Urban Design Assessment

GMU Ref. 15054

Proposed Residential Flat Building 2-4 Chester St, Epping

April 2015

Figure 1- Use this Key diagram to Building components referred in further discussions (Front portion, Central Junction & Rear portion)

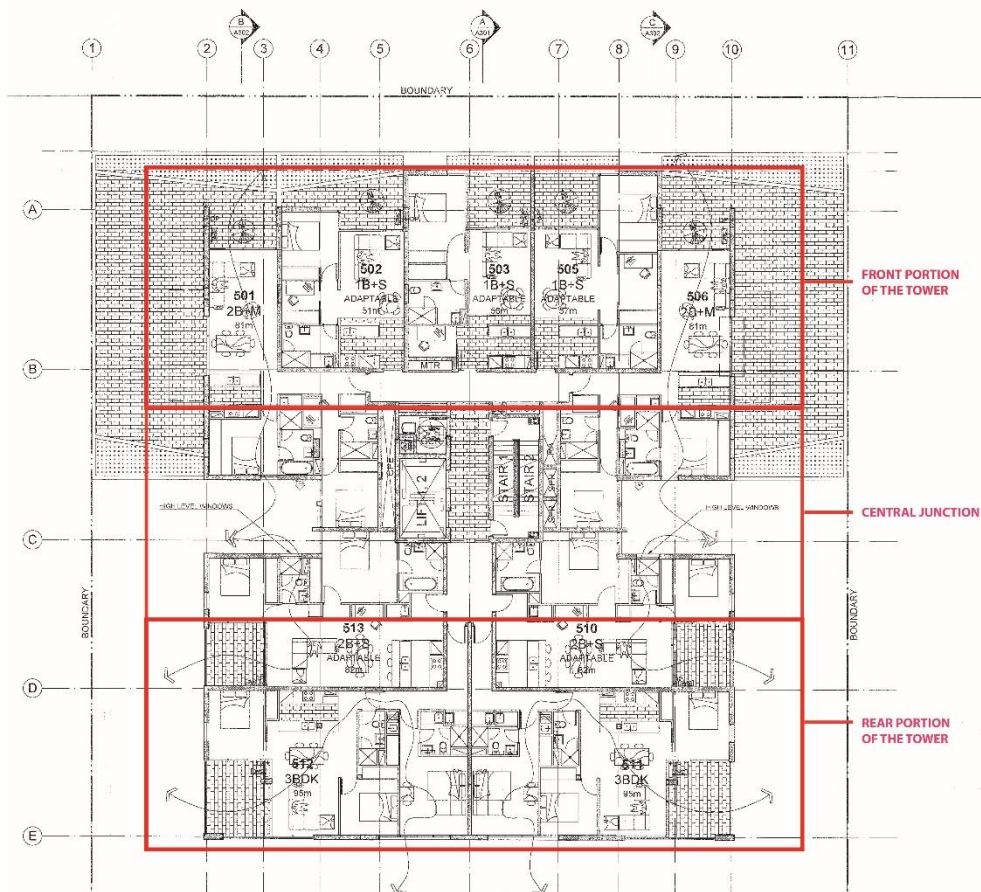
- Levels 1-3 and rear part of level 5 forms the podium (noted that Level 4 is deleted). On levels 1-3, the building depths of the front northern building portion is approximately 17m glass to glass. However, on levels 1-3 and 5 the rear southern building portion has approximately 20.4-28m.
- On the higher levels, the front portion of the building depth, on levels 7-16, is approximately 16.5m.
- In the rear portion, the building depth for levels 7-9 is approx. 22m and for levels 10-17, it is approx. 15m.

The additional depth above the RFDC standards compromises the apartment layout and amenity, such as ventilation and solar access. This is especially the case for units on podium levels and units at the central junction throughout the building. For more details, see 2.3 Building Design to follow.

GMU recommends the building depth of the rear portion of the podium to be reduced in length to around 18m (glass to glass). See Figure 2.

Figure 2- Recommendations for building entry and building depth at Level 1. Possible arrange with consideration to pre-DA scheme submitted

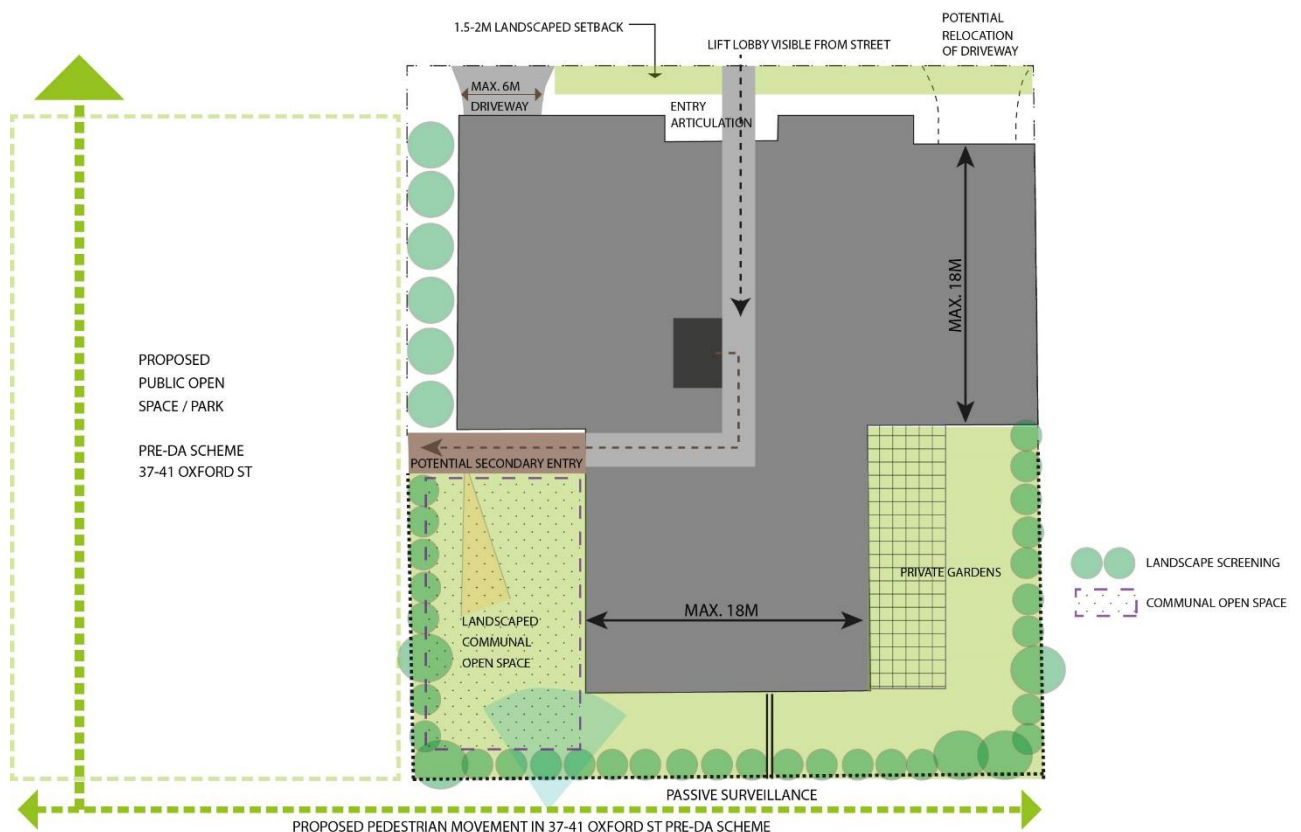
The main safety concerns are the proposed communal open space and the convoluted corridors to the lift lobby.

The RFDC recommends design to minimise opportunities for concealment especially around the lifts and common areas. GMU recommends the applicant to reconfigure the building entry to have direct visibility into the lift lobby.

The proposed pedestrian entry is not well articulated, as a narrow corridor on the side. As discussed above and shown in Figure 2, a direct access from building entry to lift lobby should be provided to enhance safety and visual connection to the street.

- Direct entry from street, allowing clear visibility into the lift lobby area;
- Reduced building depth to enhance internal amenity;
- Increased area for a communal open space;
- Secondary entry from a potential new open space to the west and from the communal open space;
- Limited depth of building to the RFDC required 18m glass-to-glass;
- Potential change of driveway if found appropriate; and
- Landscape screening to screen the private areas from the public areas.

Figure 3 Snorkel windows in Level 1

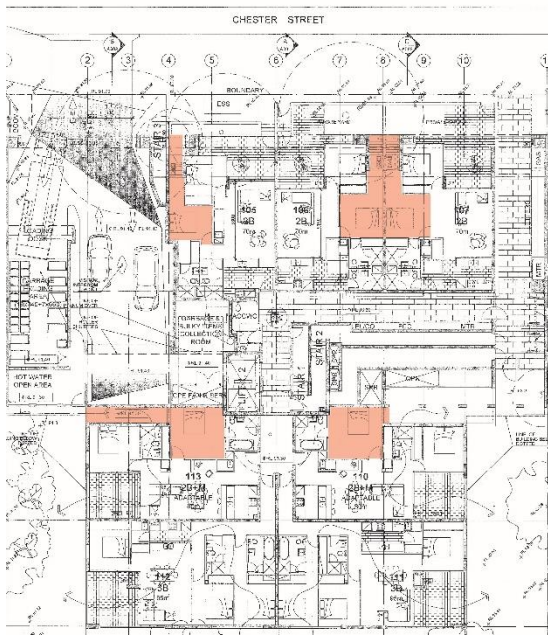
- All Chester St facing units at podium levels 1-3 have extremely narrow and undesirable snorkel windows to master bedrooms. Likewise to Units 110 and 113's master bedrooms which also are adjacent to building servicing ducts.

- Explore split level apartments for podium levels and to be access at alternate levels. This can increase opportunities for cross ventilation, privacy, access to larger private open spaces and shorter building depths. Cross over apartment configuration can also be combined to create apartment mix and accessibility.
- Provide opportunity to access apartments from common landscape areas to create passive surveillance
- The width of the recessed portion of a window (in a snorkel window) should proportionally be equal or less than the recessed depth. To achieve that we consider that the unit layout and mix needs to be adjusted especially at the turn of the building (central junction – See Figure 1).

Figure 4: 'Snorkel' or deeply inset windows in Podium Levels and level 5-9

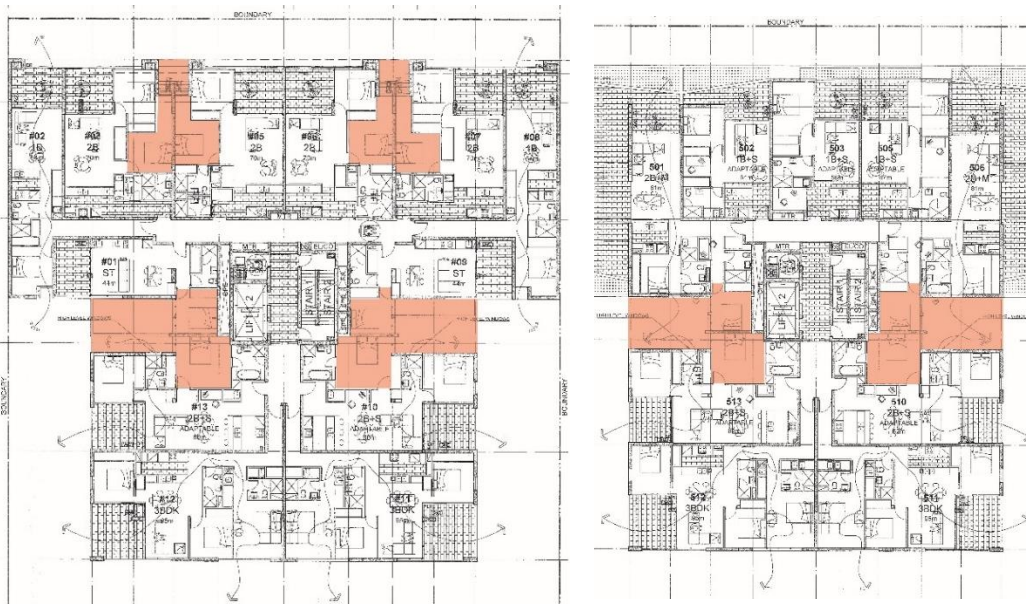
- At the central junction, apartment bedrooms in this location throughout the podium and tower level have 'snorkel' windows.

Figure 5 - Unit 1 and 9 on Level 2-3 near lifts (central junction)

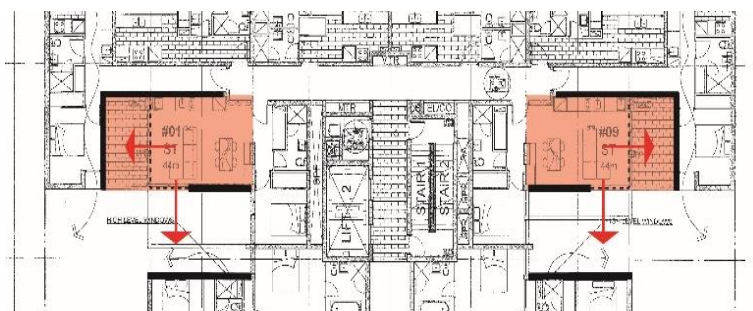
- Amenity for south facing units 1 and 9 on levels 2 and 3 are especially limited. All windows of the living areas of these units only look onto blank walls.

Figure 6: Facade to respond to height and zone transitions at the edge of Epping Town Centre

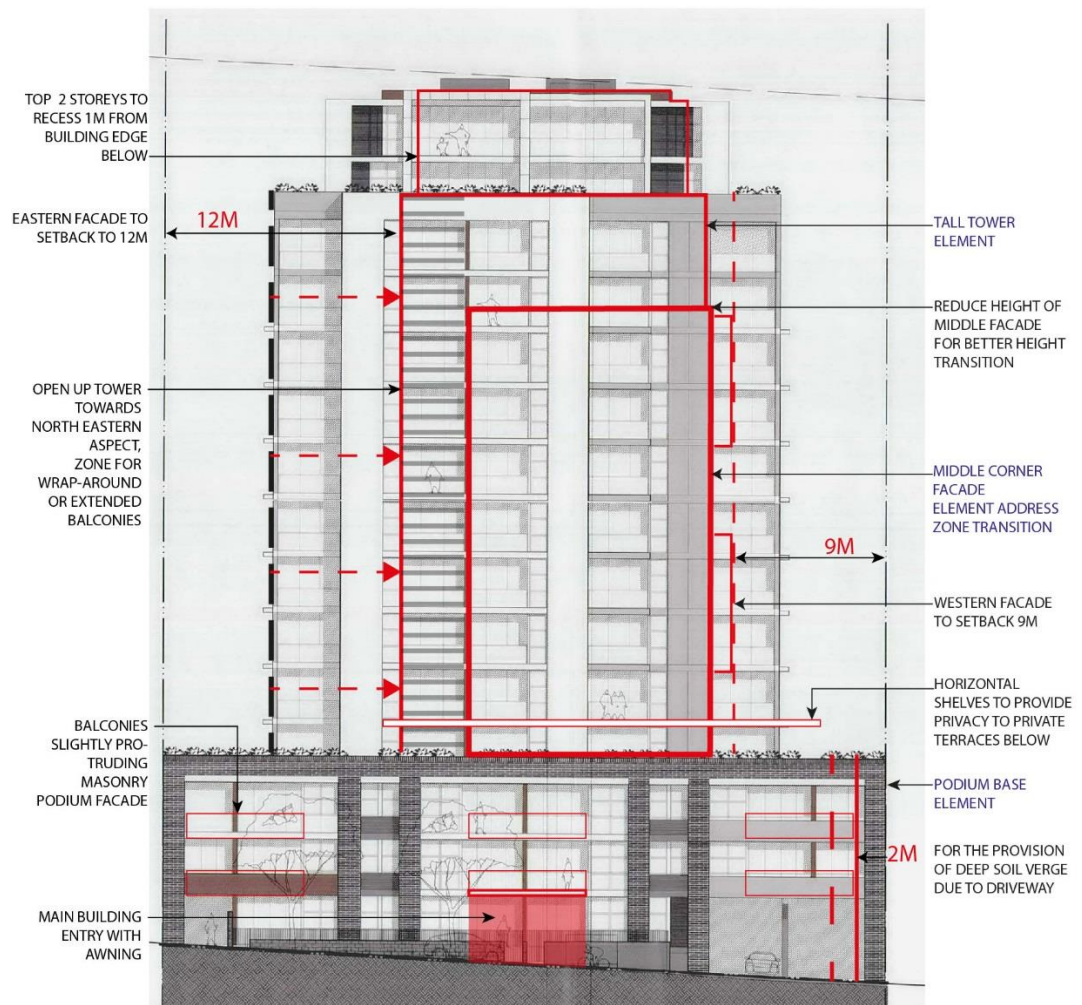
As mentioned in 2.1.5, due the zone and height transitions in this area, GMU suggest the tower to be further set back in respect to future residents' amenity in accordance to HDCP and RFDC. Façades to be setback 9m from eastern boundary and 12m from the western boundary, throughout levels 5-15 to both front and rear portions of the tower. These recommendations are made to promote better internal amenity and amenity for future tower developments in surrounding area, by creating a slender tower with lower facades to respond to scale and zone transitions (from the B2 zone 72m to 17.5m R2 zone) to better pedestrian friendly environment. The eastern setback allows balconies to north-eastern aspect. Further, the podium 2m setback on the side, if considered in conjunction with the pre-DA 37-41 Oxford St, it has the potential to open up this corner to address the future public domain space and allow podium residents more solar access and ventilation. See Figure 7.

Located on the Epping Town Core Centre, it is therefore prudent that this subject development's façades respond to the transitions occurring at the Centre's edges to set good principles for future neighbouring developments to minimise a 'cliff edge' impact towering over R4 developments across Chester Street. The visual impact of these heights above lower scale developments should also be taken into consideration.
